REVISION (1) TO SAFETY ANALYSIS REPORT (SAR)
FOR LOW ENRICHED FUEL OF THE RHODE ISLAND NUCLEAR SCIENCE
CENTER RESEARCH REACTOR

- 1) Replace pages 17 and 18 of the original document with
new pages 17 and 18 CH-1
- 2) Replace Appendix C, pages 25 and 26, with new pages 25
through 30 CH-1
- 3) Delete Appendix D, pages 28 through 32.

FIGURE 1-23 BEAM PORT

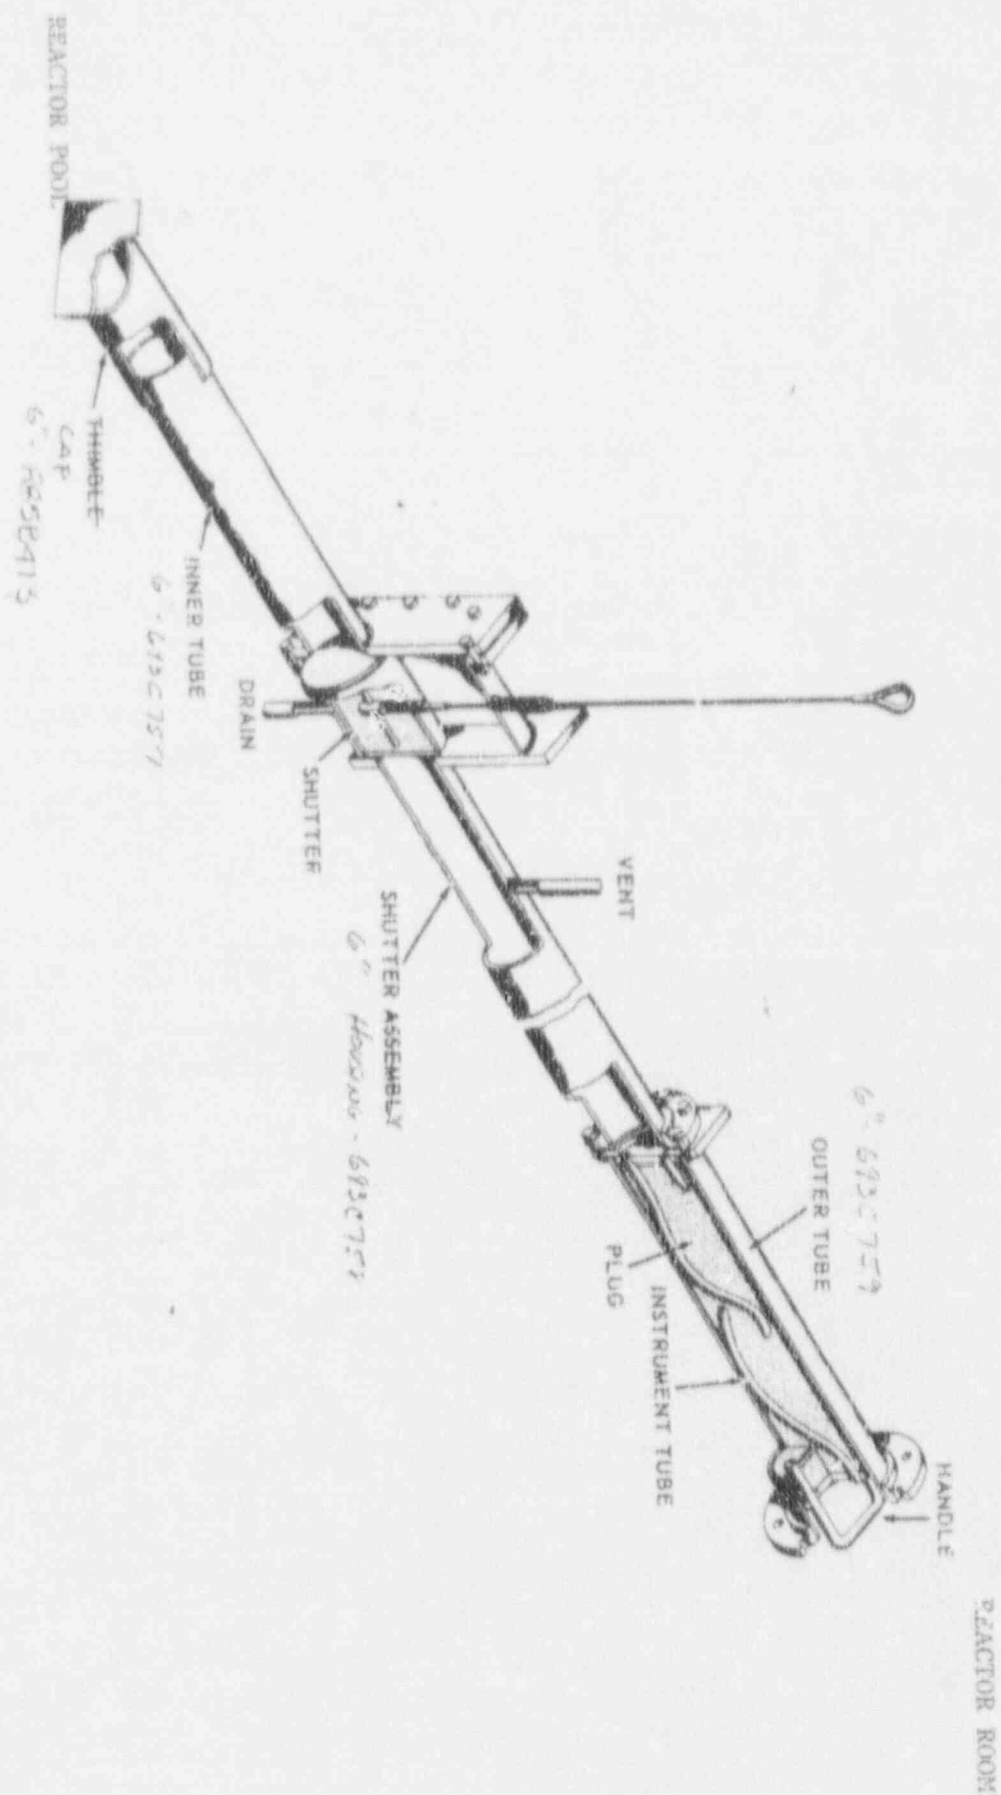
A typical beamport is shown in figure 1-23. Four barriers to loss of coolant can be provided; not all beamports have all four barriers. The first barrier is the beamtube itself. The fixed experiment barriers (one on each end) limit any leakage area such that a beamport failure will be less than the pool makeup fill rate of the hydraulic head imposed by the pool. The beamport shutter serves as another barrier, but the shutter is raised when a beamport is in use which eliminates its utility. Finally the flanged cover plate serves as a fourth barrier.

At the RI Reactor, every beamport or through tube is configured with at least two of the barriers. The through tube has two of the barriers; the through tube itself and a flange at each end. There are three six-inch beamports not in use having three of the barriers; the beamtube, the shutter in closed position, and a flange installed. The three remaining beamports have a minimum of two barriers; the beamtube itself and the experimental barrier(s) described above.

Appendix A shows the calculations leading to the result that no experiment will be approved or installed with a barrier having an opening greater than the equivalent area of a 1/2 inch diameter hole. The fixed experiment also implies that it shall be designed and installed to withstand the backpressure equivalent of the hydraulic head of the pool, or a minimum of 25.09 feet of water pressure.
